ADDENDUM 4

FEBRUARY 20, 2024

**REEFER SERVICE AREA, PORT OF WILMINGTON
SCO#: 22-25839-01**

Questions received:

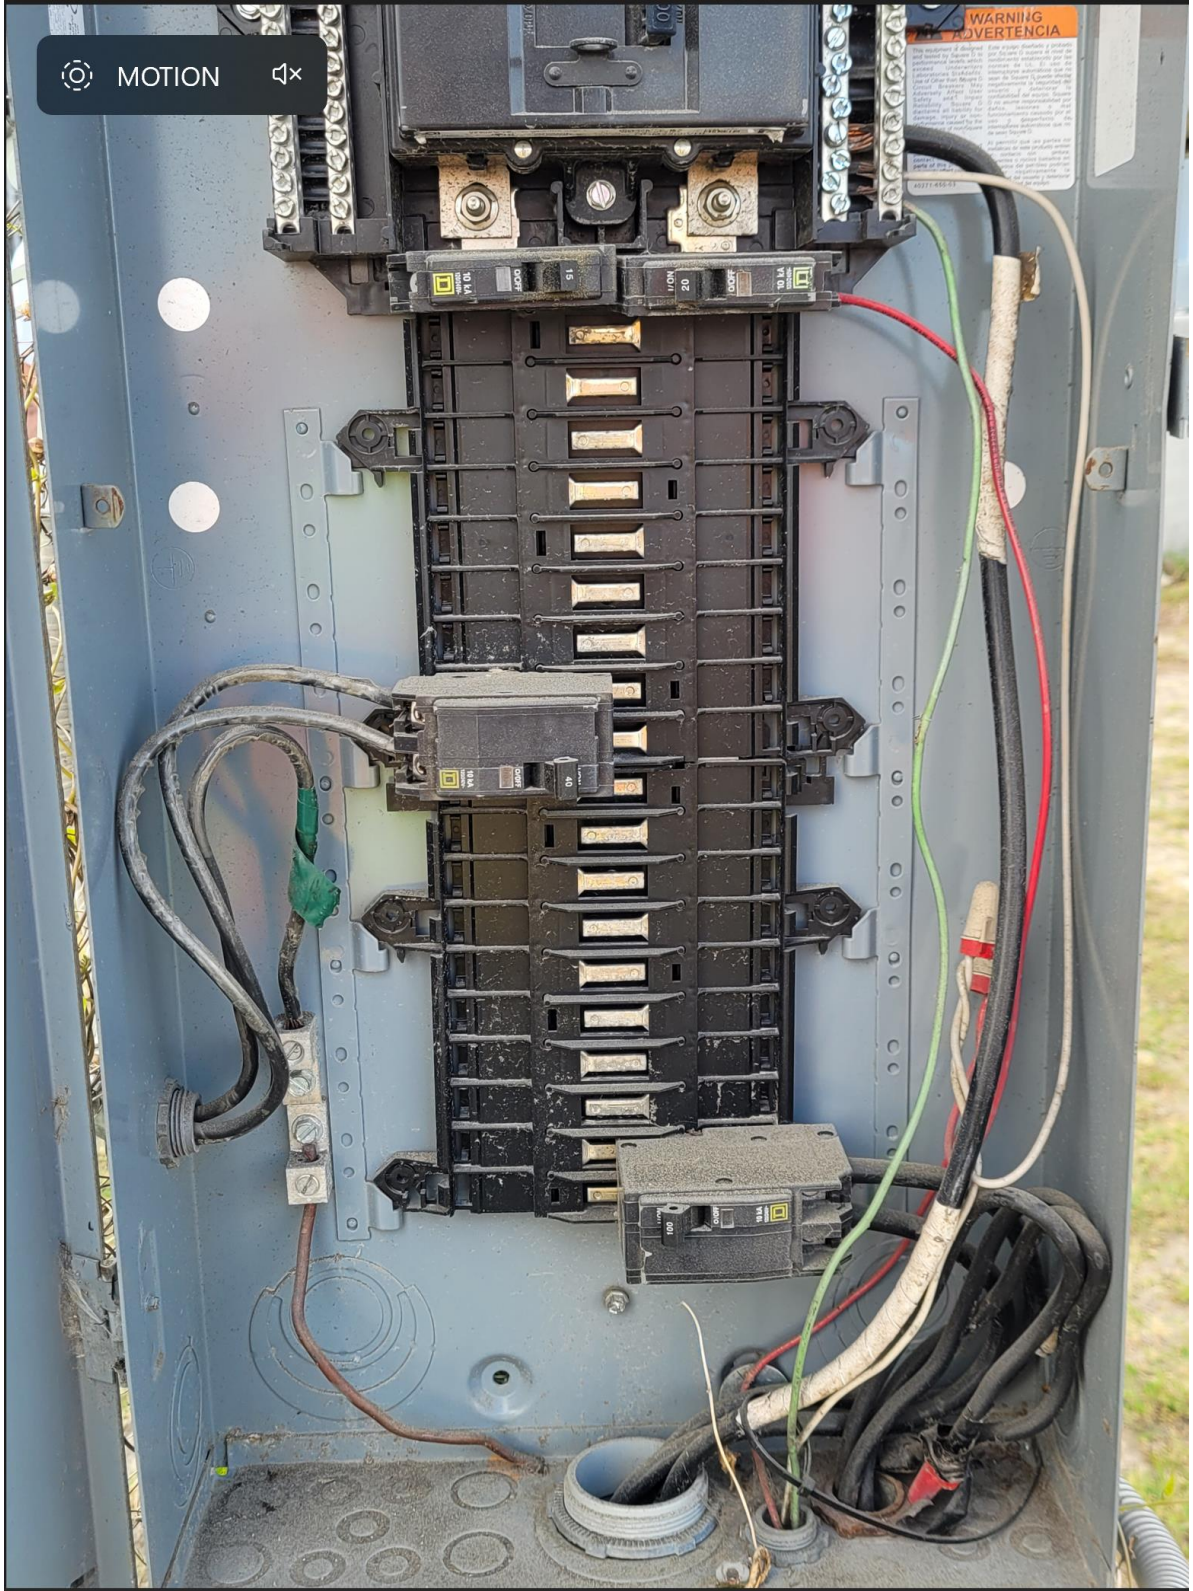
- a. **These are two separate conduits. The 5kV MV cable will in one 4" conduit while the remaining wires in the second conduit shall be used to refeed the existing loads currently located on the utility pole existing panel (Picture attached).**

8. On the panel schedules ...What is the "existing loads" in Panel PP-2 and what will need to be hooked up for them as far as conduit and wire sizes?
 - a. **Refer to comment #7 response. These are existing loads in the existing panel (Picture attached).**

ELECTRICAL LEAD SHEET, SCHEDULES, AND DETAILS

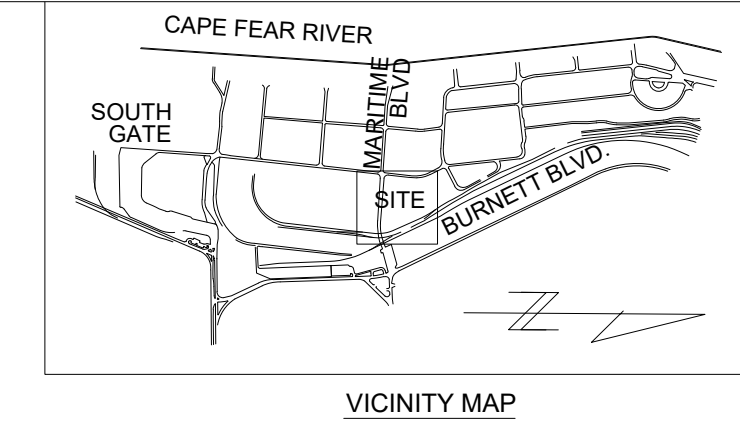
- a. **Panels, like all other outdoor equipment, should be 4X. This is also stated in the contract specifications. Drawings will be revised.**
4. What size junction box is recommended for the Square "J" symbol on the drawing?

- a. **Canopy mounted boxes shall be 16"x16" minimum. Receptacle junction boxes are just device back boxes.**
5. What is the purpose of a Junction box at each device?

1. REVISION: Replace existing plan sheet E-101, E-103, and E-105 with attached revised plan sheet E-101, E-103, and E-105 with noted Revision 1, Addendum 4 dated 2/14/2024.
2. REVISION: Replace Page C-3 of revised Section C provided in Addendum 1 with revised Page C-3 attached.

ELECTRICAL ENLARGED CANOPY SITE PLAN
SCALE: 1/8" = 1'-0"

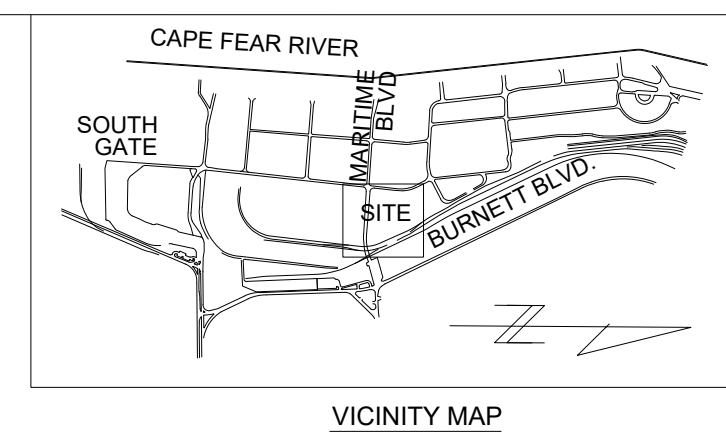
6. Are the conduits that feed the WP GFI receptacles and the 480V receptacle meant to be mounted on the column with the conduit coming up through the concrete poured around the column?

9. In the 2" conduit from the "Electrical Rack" that shows "(6) SETS 2#8, 1#8 in 2"C" does the engineer really want multiple voltages in the same conduit, or should you have one conduit for the fans that are 277-Volt and a separate conduit for the lights that are 240-Volt ... or should the lights be changed to 277-volt?

10. What, other than the breaker, is the means to turn the lights ON and/or OFF? Should there be a switch added on one of the columns or a photocell at the panel?

- a. **Yes.**
7. What is the purpose of the 5#12, 2#8 and 1#10 5KV medium voltage cable in the 4" conduit? The smallest 5KV wire we can get is a #6 which we should only need 3 strands to feed the 4160 transformer ... correct?

- a. **While multiple voltages (power) are allowed in the same conduit provided the wiring insulation is rated for 600V and the wire colors follow the contract specifications, it will be a cleaner installation if the canopy lights are also fed from PP-1. Drawings will be revised.**

- a. **The lights will remain on at all times from our understanding and a switch on one of the columns would be a good addition. Drawings will be revised.**
